CONVAIR

COMMERCIAL CHANGE PROPOSAL

SPEC NO.: ZD- 22-002

MODEL: 22-1 (Convair "880")

Figure 3.19-4

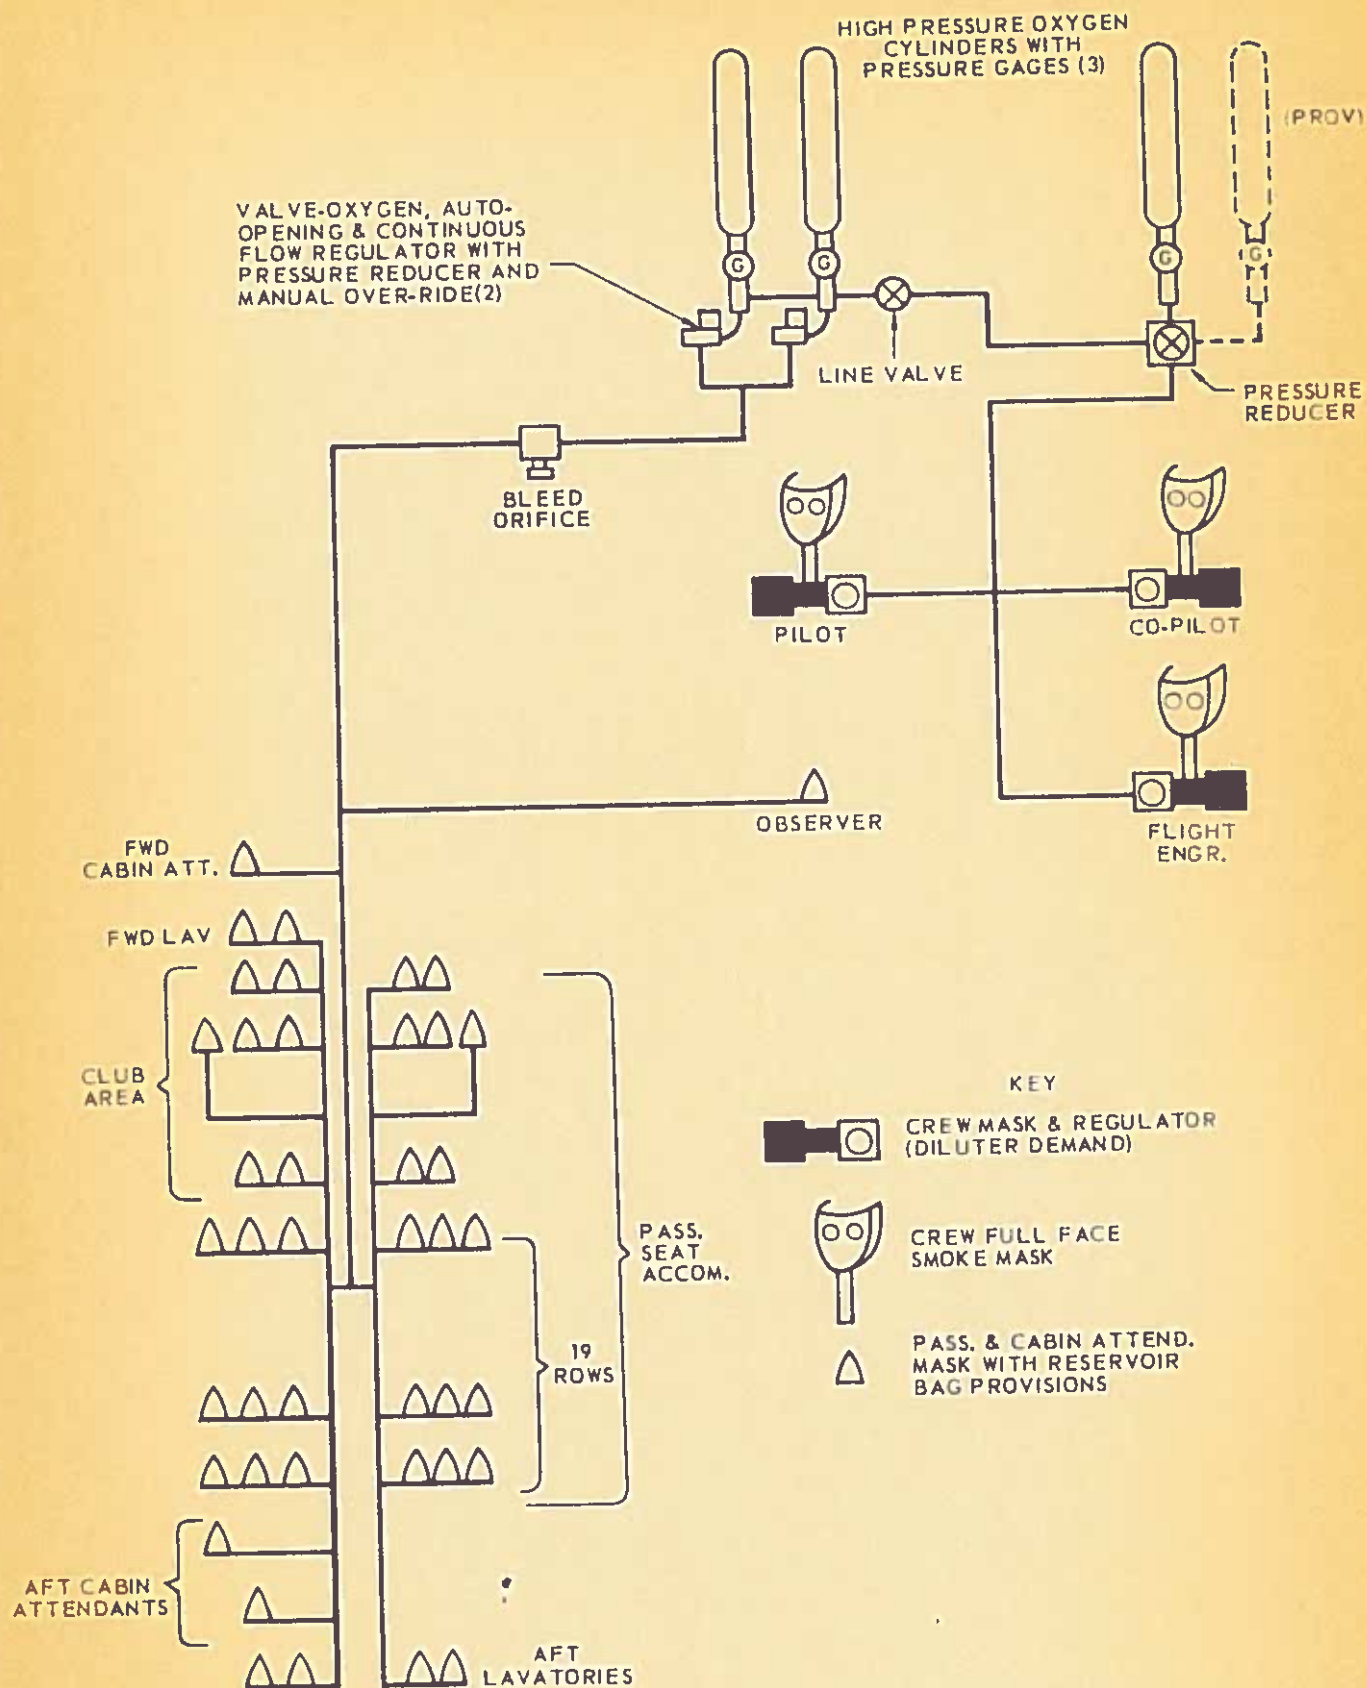
Provisions for one additional mask shall be made for each seat row in the main cabin area (three masks for each of the 19 rows on both sides of the airplane) to provide for emergency oxygen for children in arms. The oxygen outlet system for the club area shall be as shown on Figure 3.19-4

Above figure will be replaced in the specification with Enclosure (A) on Customer approval of this CCP.

Enclosure: (A) One copy of Figure 3.19-4 - GASEOUS OXYGEN SYSTEM (Revised)

FIGURE 3.19-2

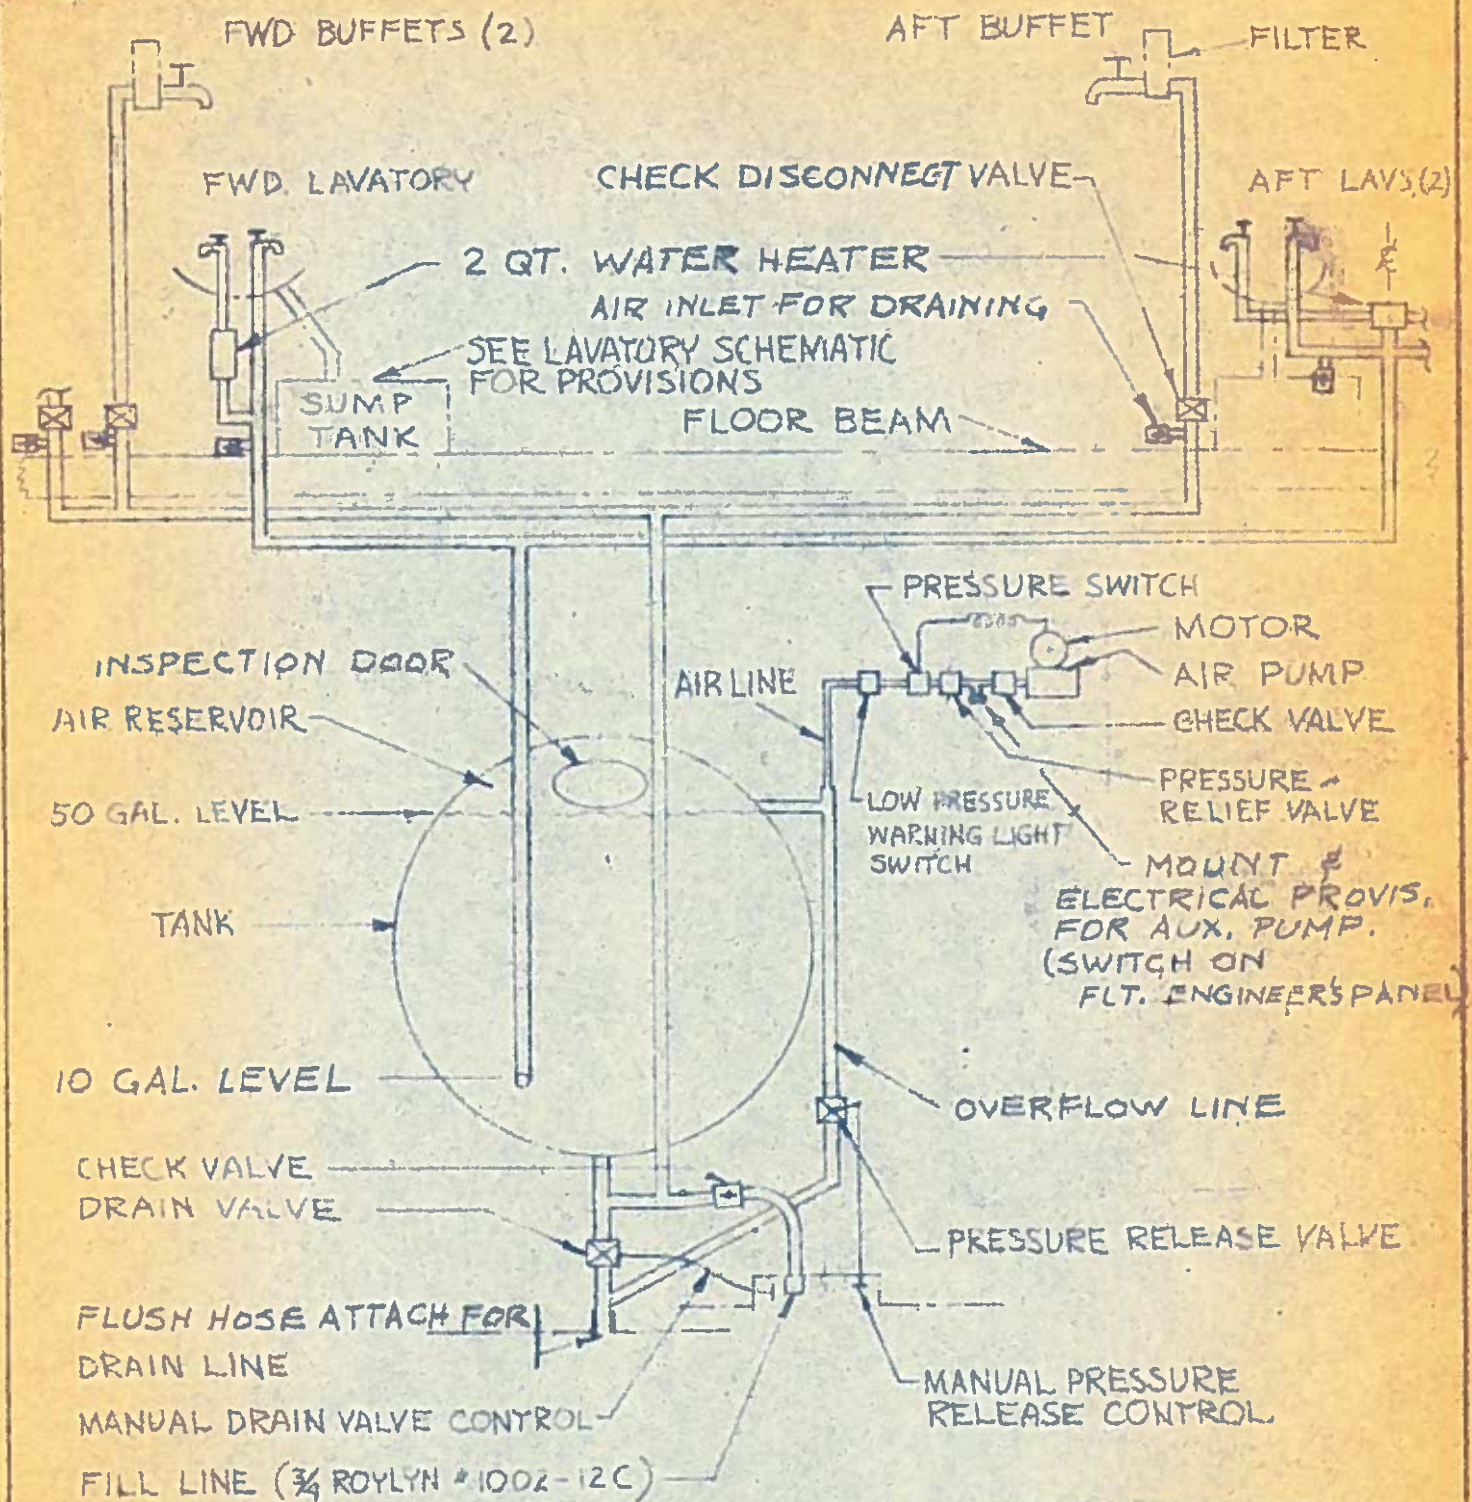
Page 110B FIGURE 3.19-2 WATER SYSTEM:

Enclosure: (A) One copy Figure 3.19-2, WATER SYSTEM SCHEMATIC (for information only)

- Enclosures: (A) One copy of Figure 1-1, GENERAL ARRANGEMENT (for information only, figure in Specification will be revised to show leading edge slats on acceptance of this Change)
- (B) One copy of Convair Drawing SD-58-03147 - WING L.E. SLAT (for information only)

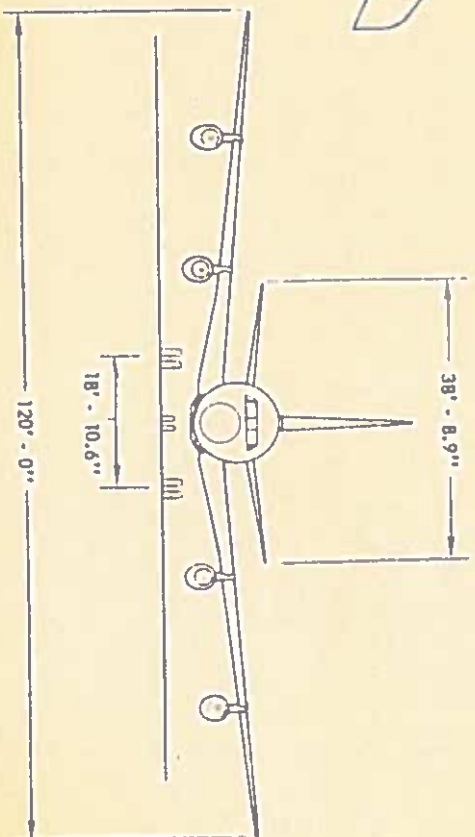
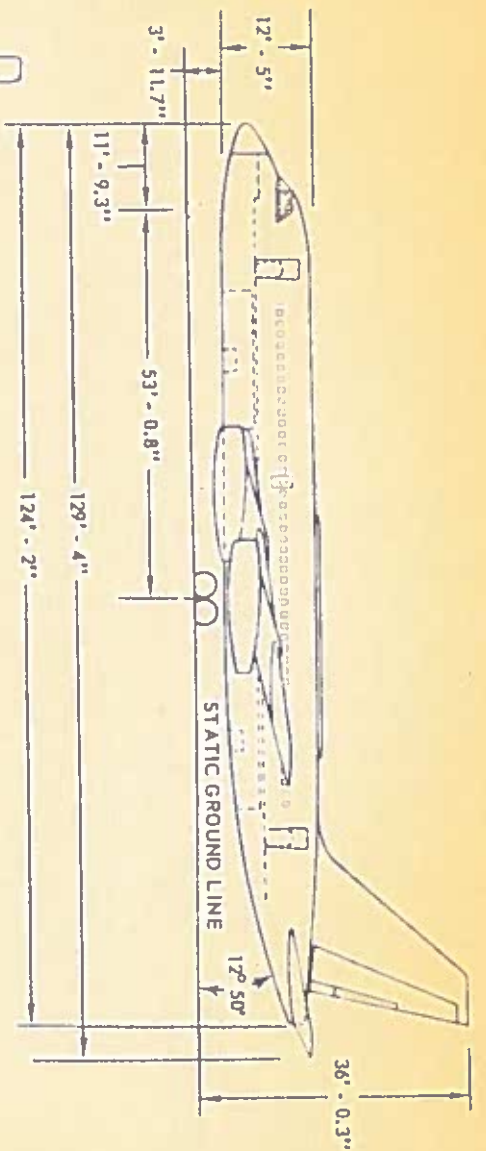
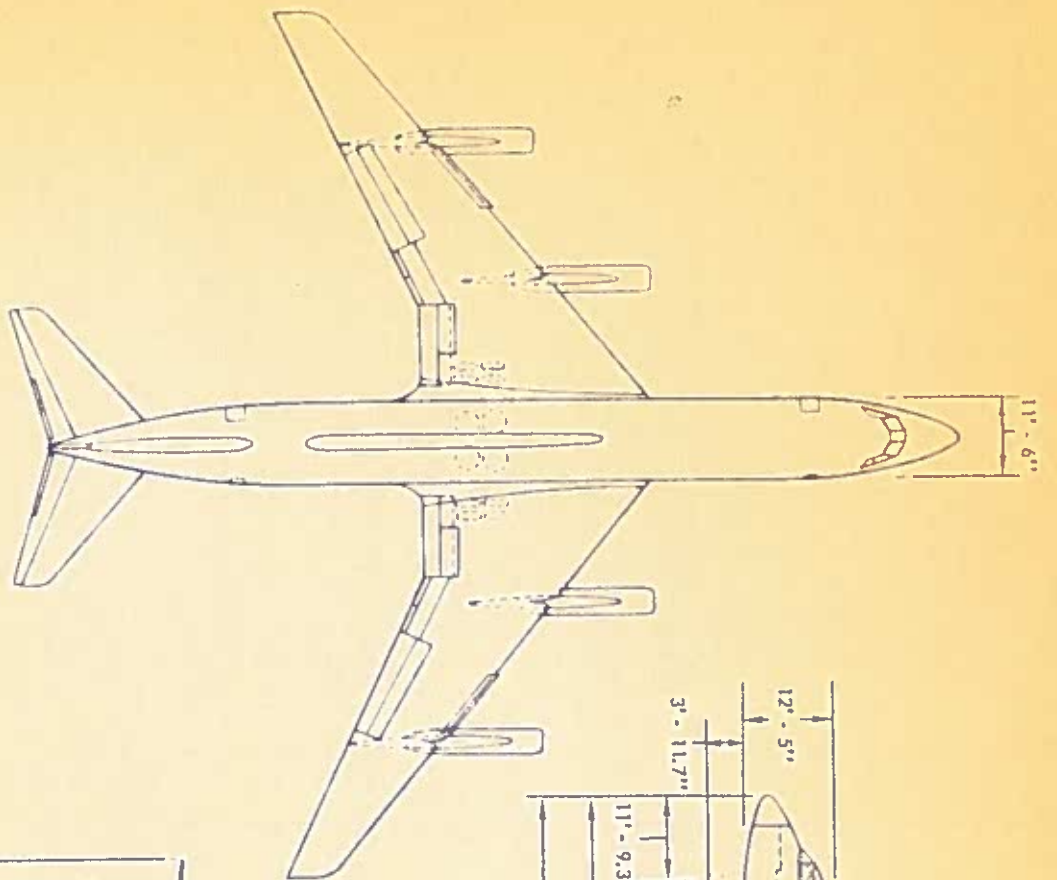
Add the following item under paragraph "4. Inherently Interchangeable Parts"

"Leading Edge Slats"

Figure 3.20-5

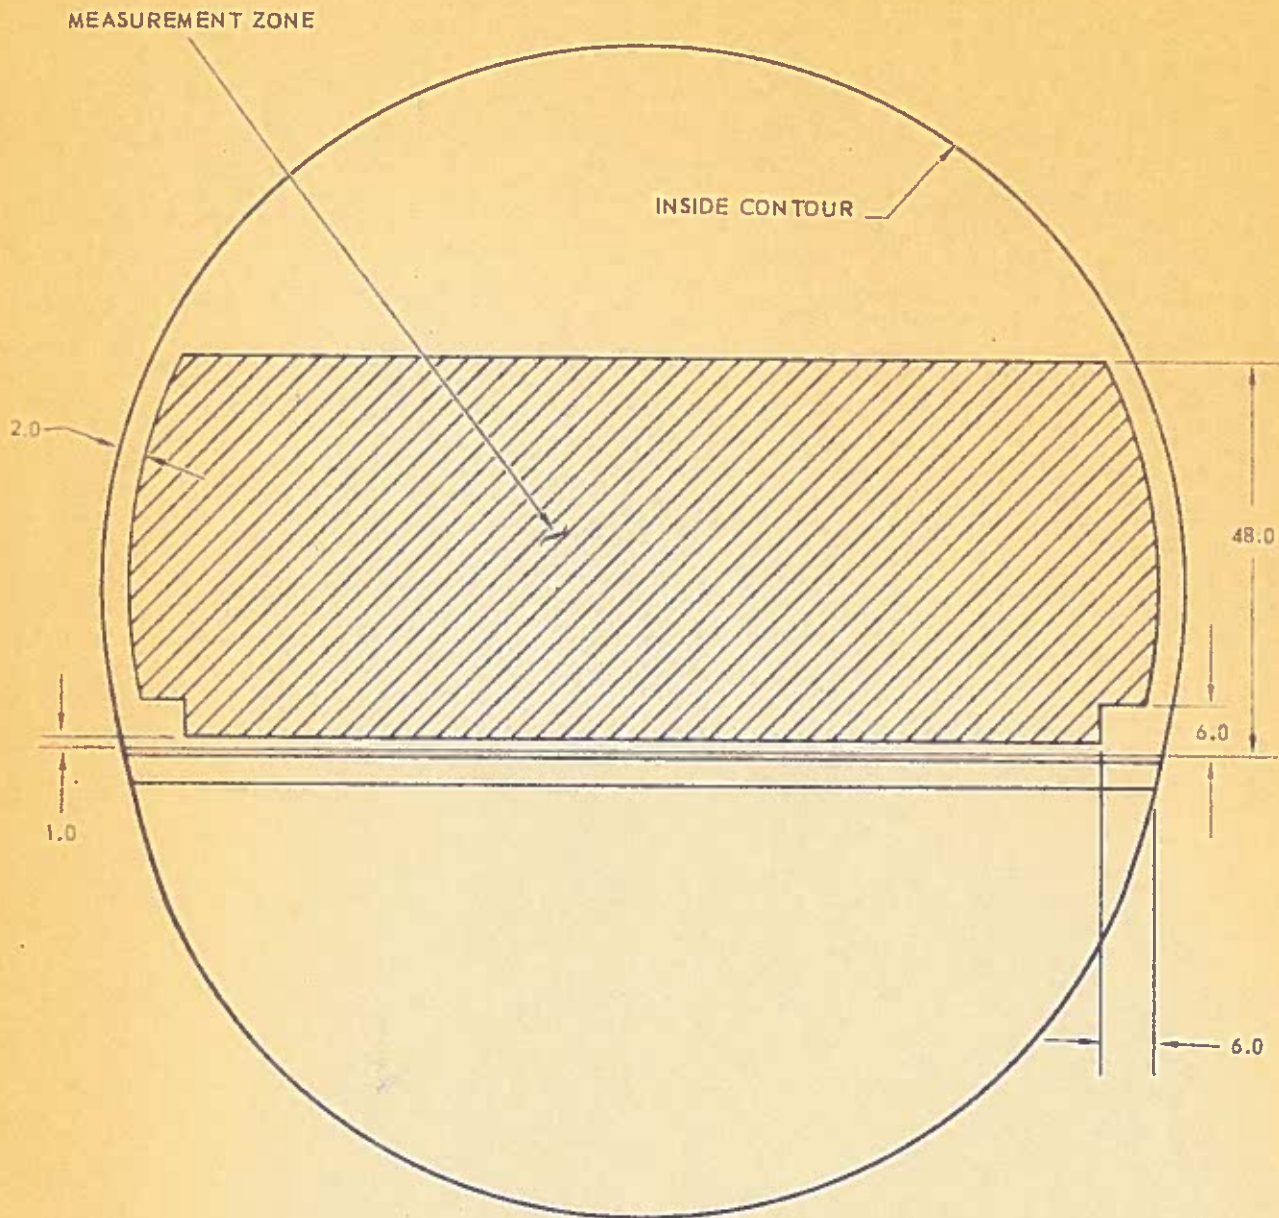
In the second sentence, change "Figure 3.19-11" to "Figure 3.20-5"

Enclosure: (A) One copy Figure 3.20-5 - TEMPERATURE MEASUREMENT
PLANE (To be incorporated into Specification on
Customer approval thereof)
